**CODE CONSULTANTS
PROFESSIONAL ENGINEERS, PC**

**RE: APRIL 12, 2006 MEETING
WTC MEMORIAL AND MEMORIAL MUSEUM
PROJECT NOS. 7383-4 & 7966-4**

RE: FIRE SIMULATION STUDIES
WTC MEMORIAL AND MEMORIAL MUSEUM
PROJECT NOS. 7383-4 & 7966-4

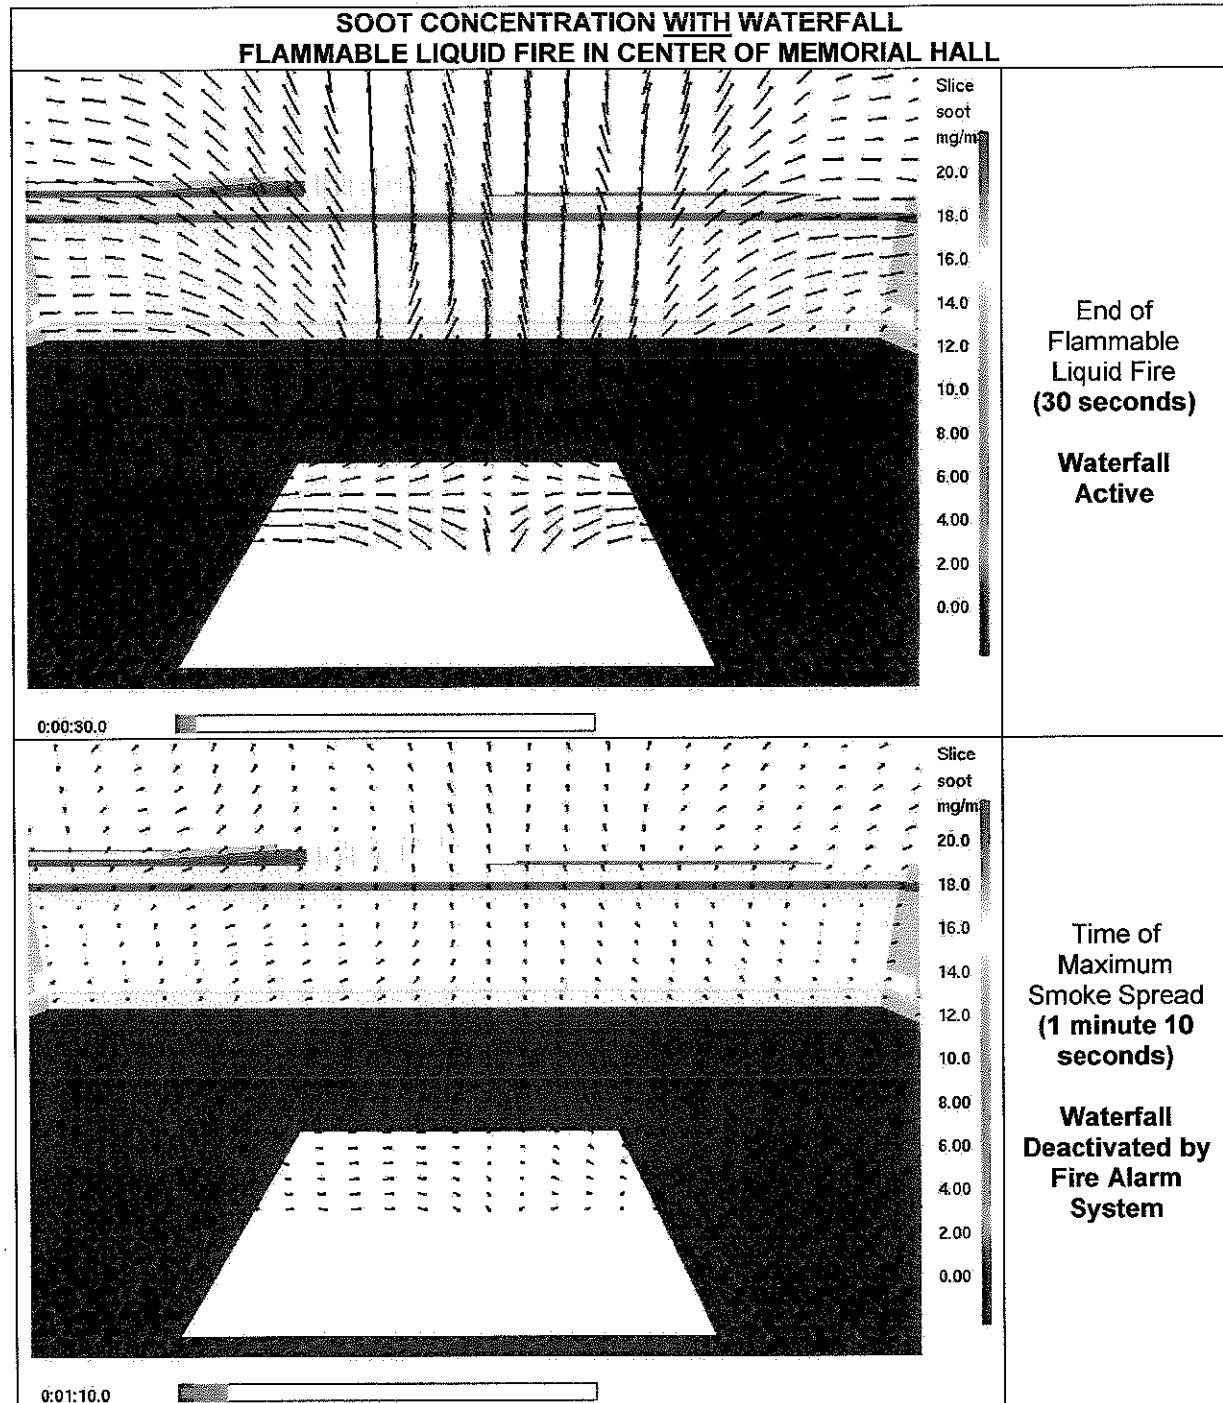
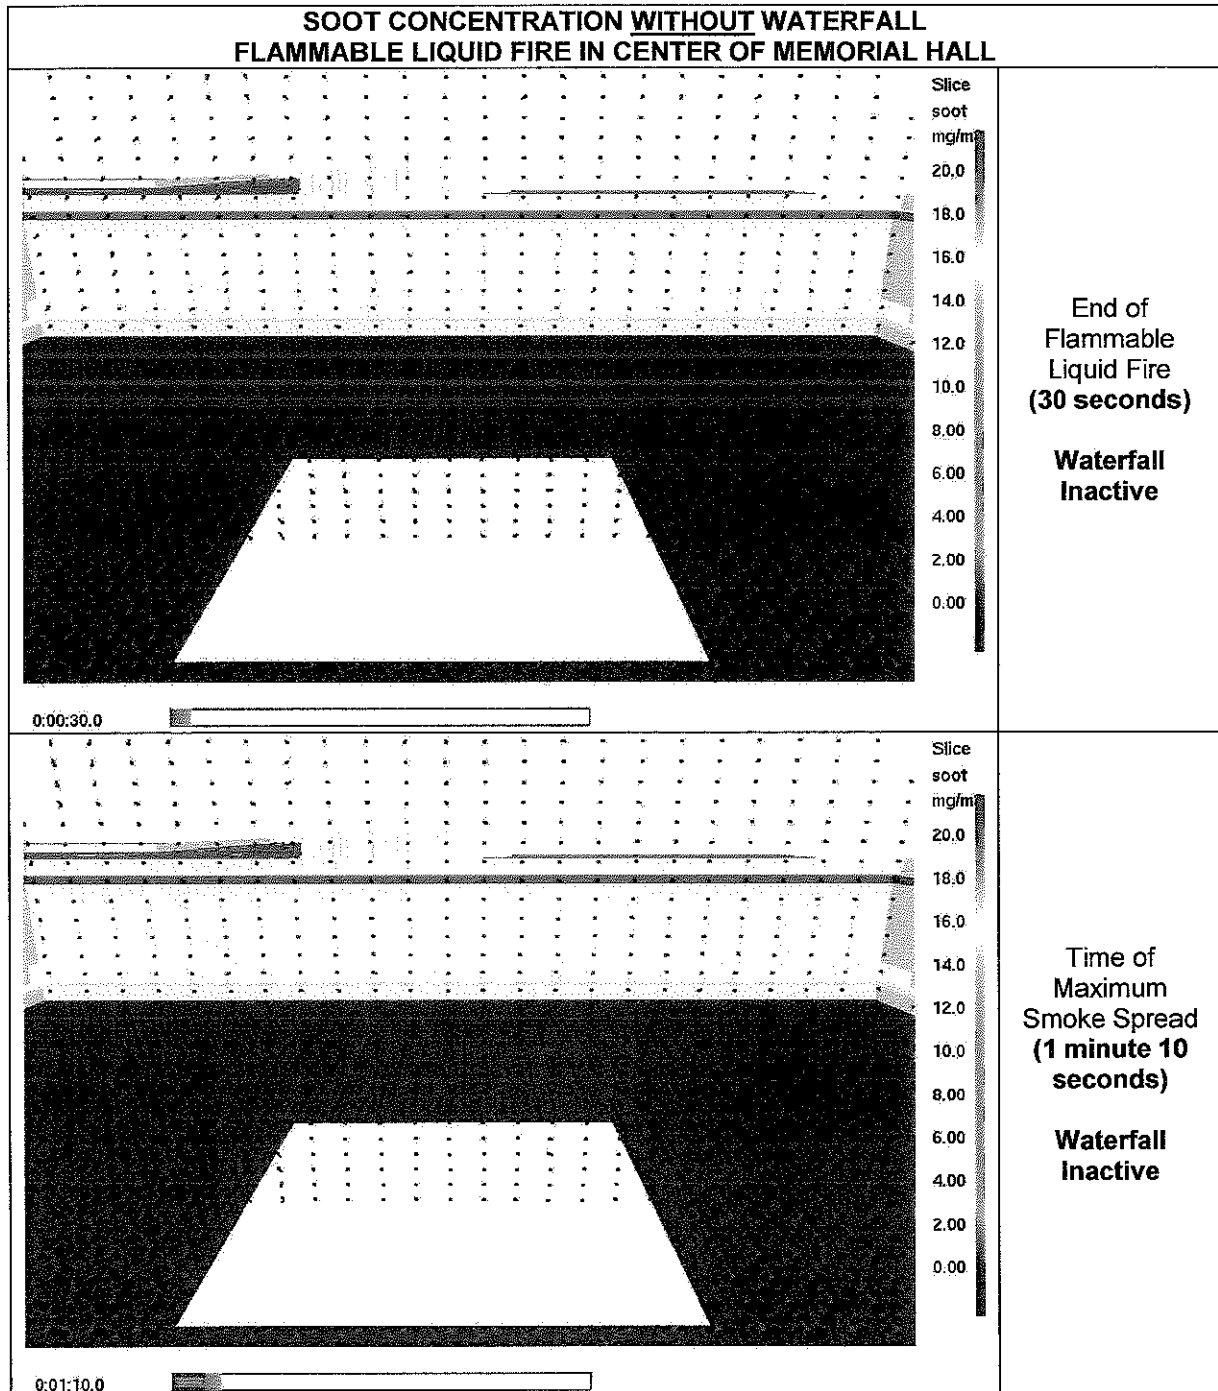
1. Responses to each of the questions in the email from Ms. Saakian dated March 31, 2006 were discussed. Responses are documented in the enclosed letters from CCI and Davis Brody Bond, LLP (DBB) dated April 12, 2006 (Enclosure A). Copies of the letters from CCI and DBB were provided to the FDNY at the meeting.
2. Mr. Subbarao requested that data be submitted indicating the concentration of soot in the air that travels through the openings at the center of the Memorial pools during the Memorial Hall fire and indicating the time at which the concentrations were measured. CCI noted that the air traveling through the openings is fresh air drawn from above the Memorial, which is not expected to carry any smoke particles.

The following tables illustrate the concentration of soot in the air flowing through the opening in the center of the reflecting pool during a 30 MW flammable liquid fire in the Memorial Hall, with and without the effects of the waterfall.

The figures above show that the air flow entering the levels below +284'-0" is induced by the waterfall, the effects of which were included in the CFD model for the Memorial. After the waterfall shuts off, the air flow entering the levels below +284'-0" is minimal. As demonstrated in the figures above, the soot concentration of the air traveling through the opening is near zero. This indicates that smoke is not traveling to the floors below. The Fire Dynamics Simulator (FDS) input files for simulations of a flammable liquid fire in the Memorial Hall with and without the waterfall are included on the enclosed CD-ROM.

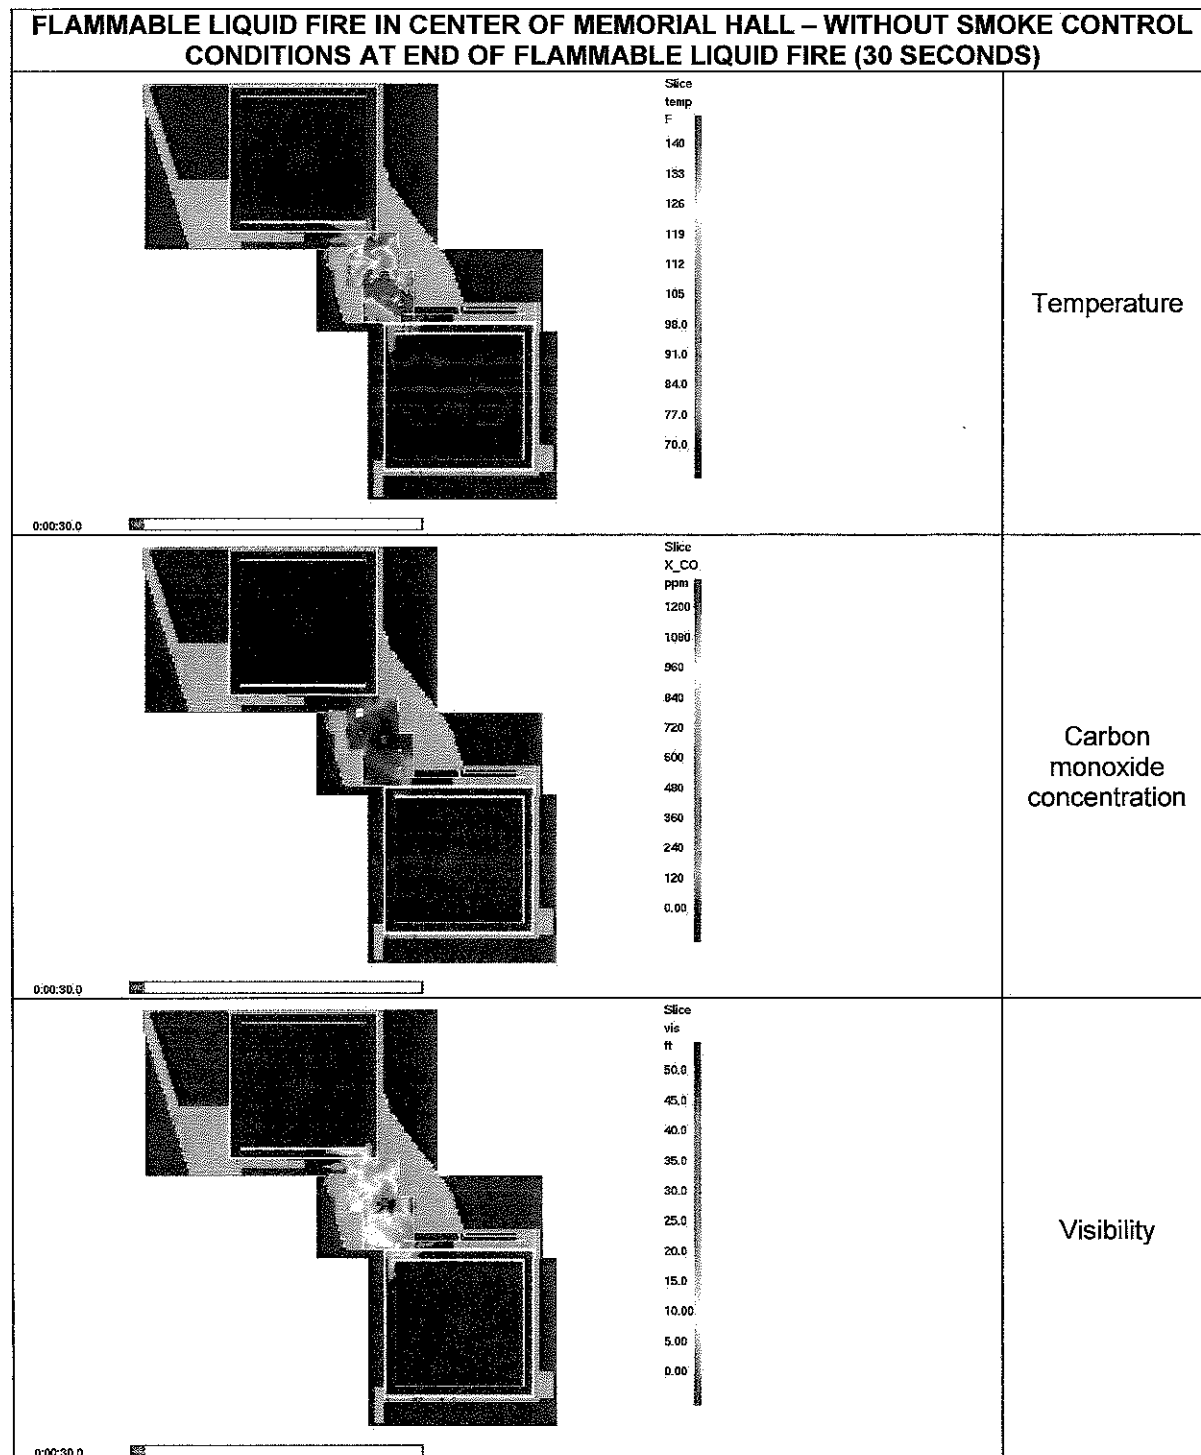
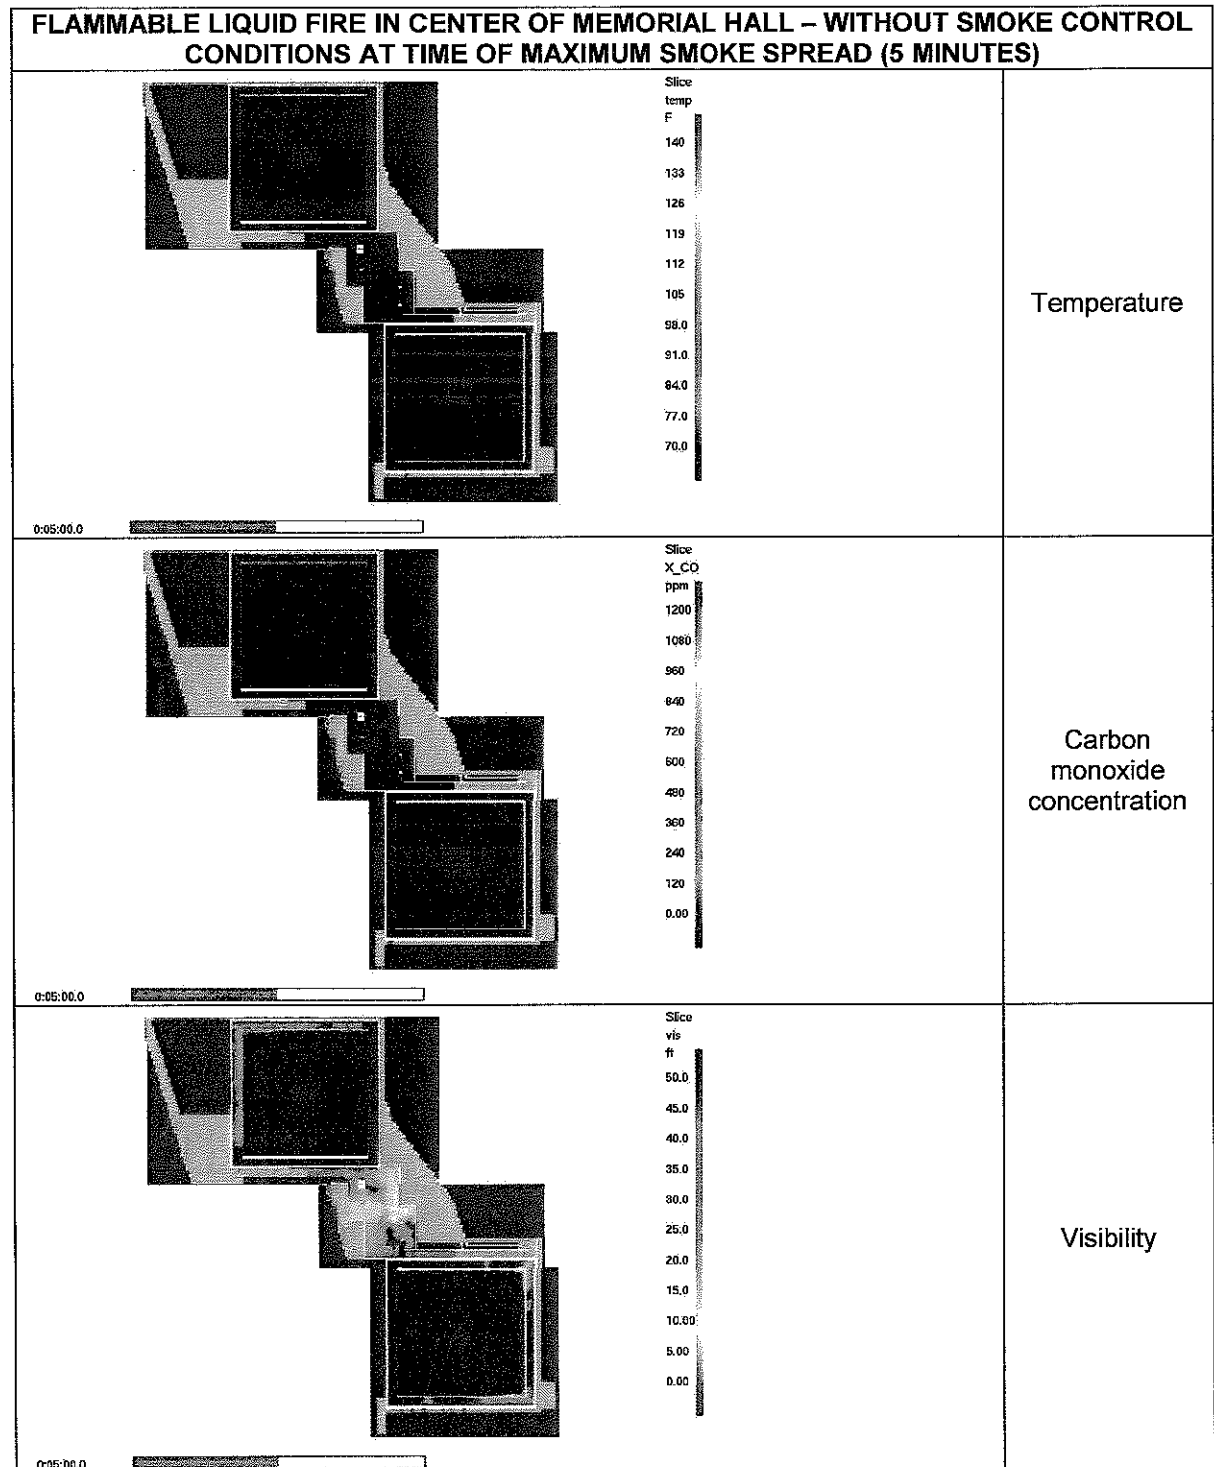
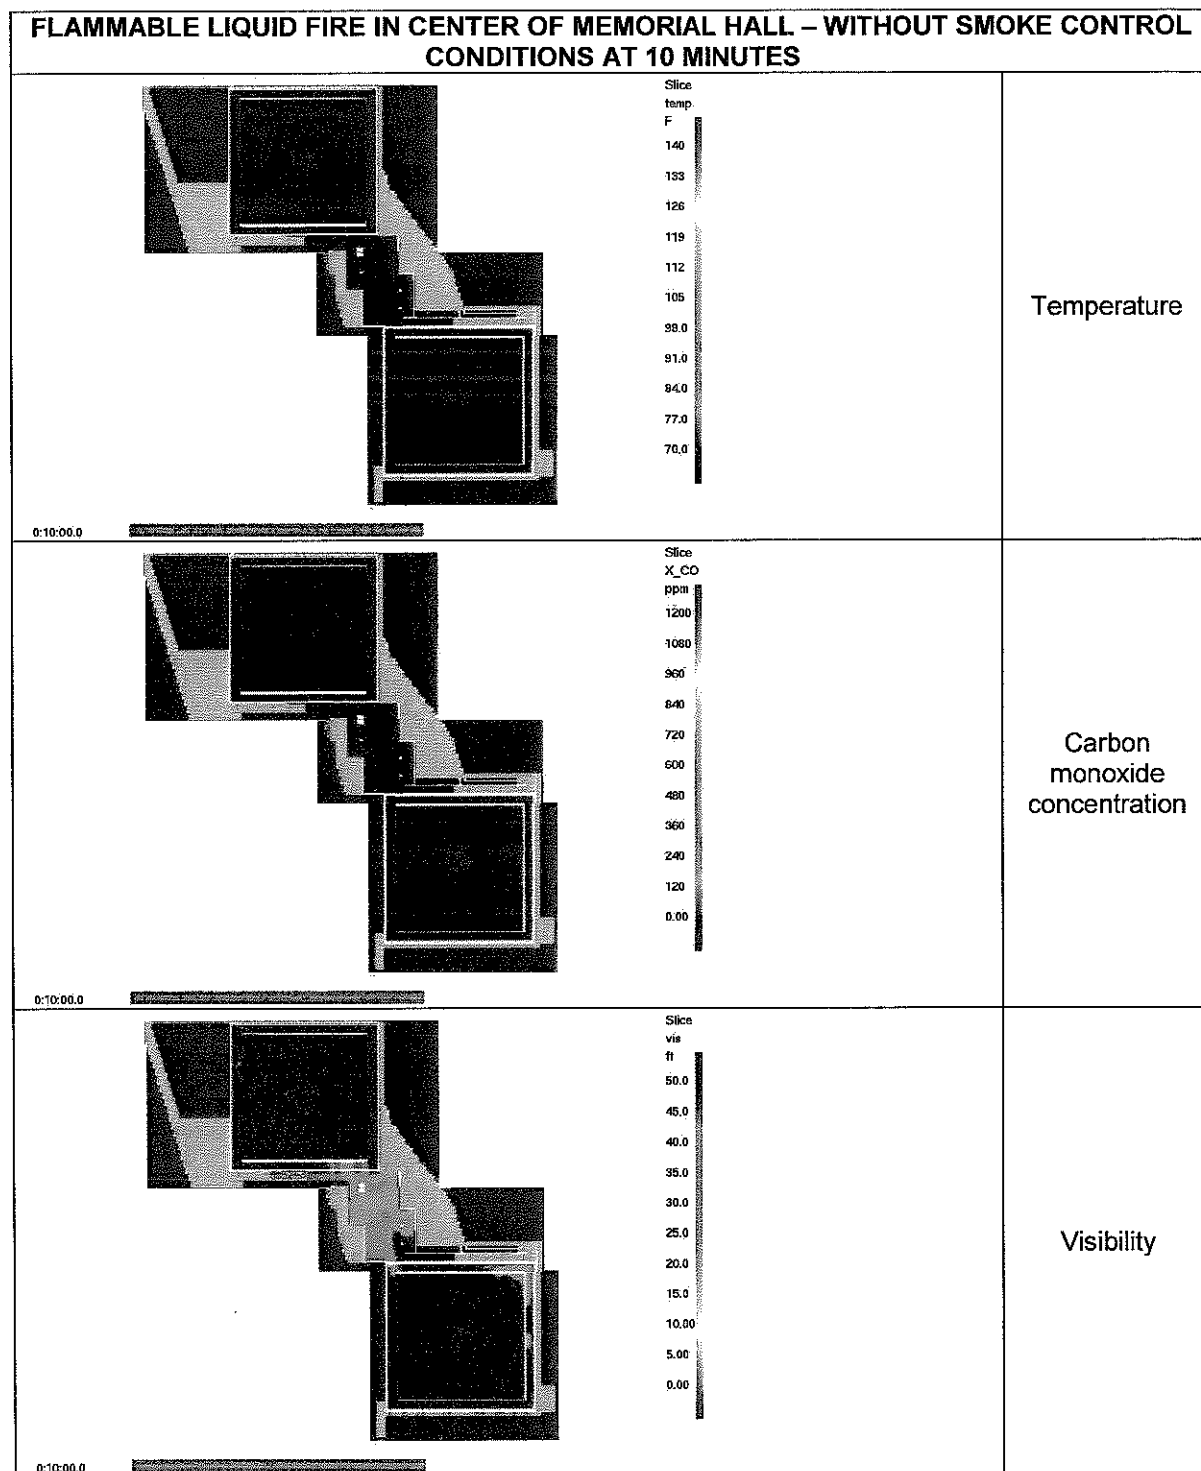
8. The FDS input file for the flammable liquid fire in the Memorial Hall was reviewed. Exhaust vents were identified in the input file and the corresponding vents were located in the Smokeview rendering.
9. Mr. Subbarao requested that results be submitted for a flammable liquid fire in the Memorial Hall with the smoke control system inactive.

The results requested are provided below. The FDS input file for this scenario is provided on the attached CD-ROM.

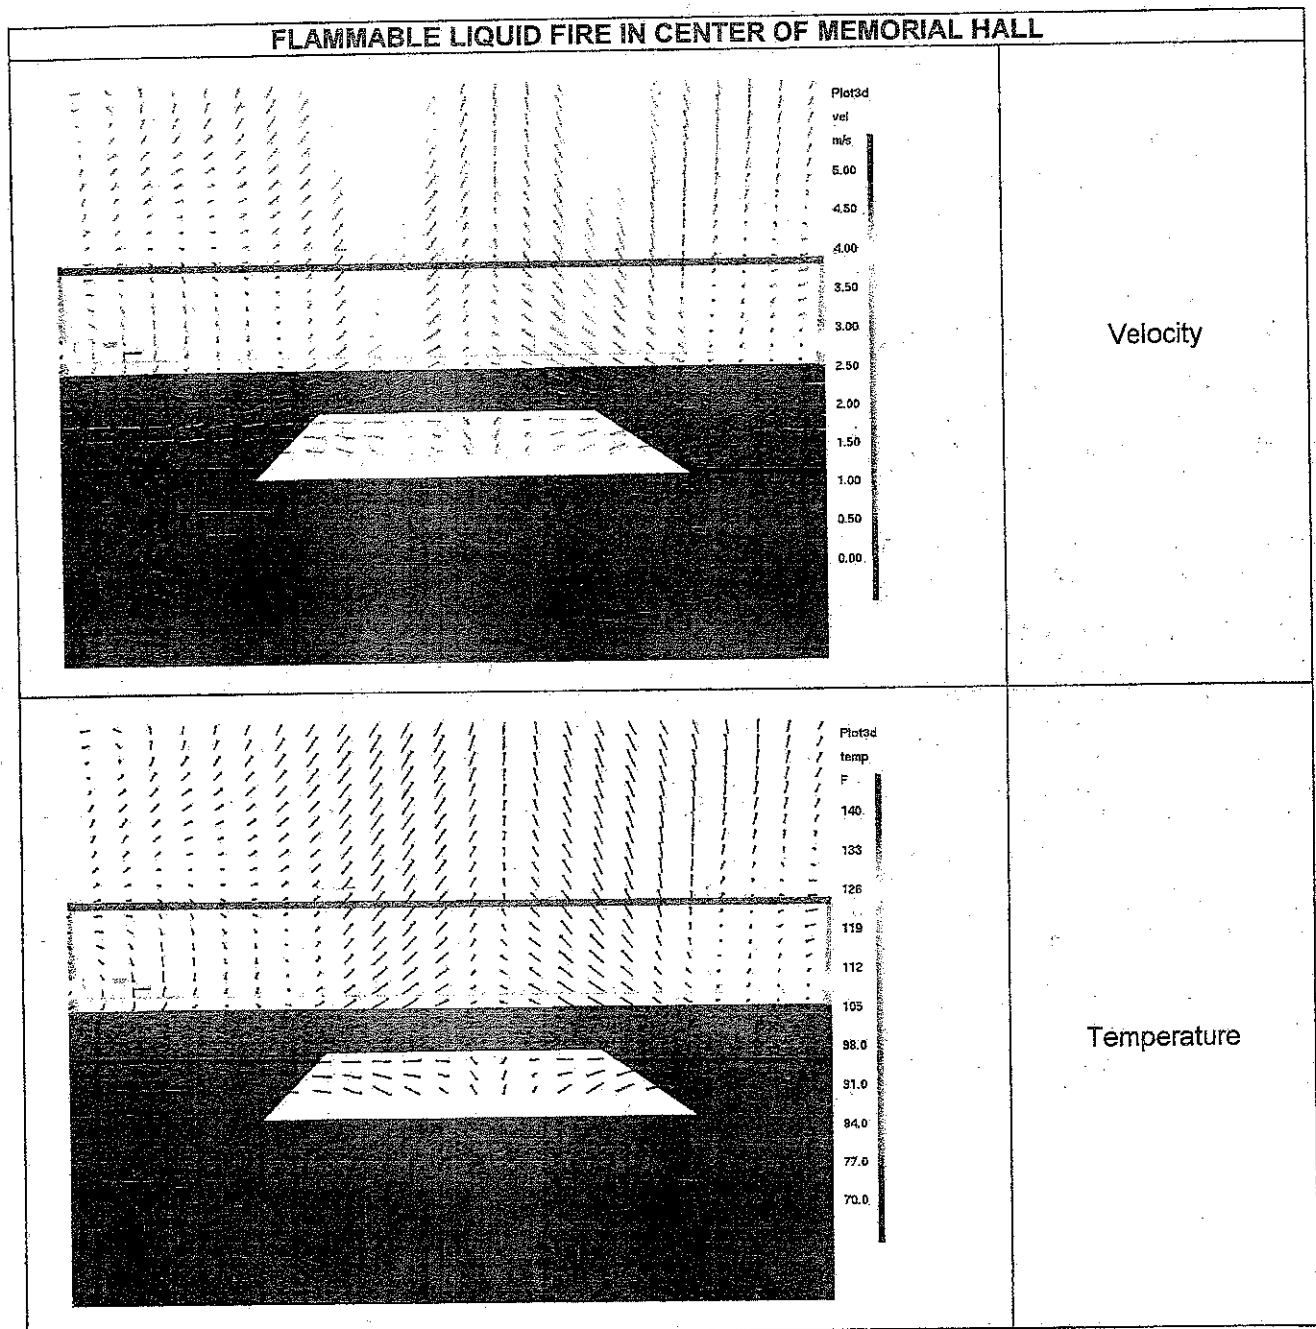
3. *An input data file was submitted previously to the Fire Department for the Memorial fire at +284. Arrange for an individual to identify the vents on the input file and smoke view and turn off such vents that may be required by the Fire Department to study conditions under a no emergency ventilation scenario.*

CCPE: Enclosed with this letter please find a CD-ROM with an input file for the requested fire scenario. Vents used for smoke control have been removed from the attached input file to simulate the conditions without emergency ventilation.
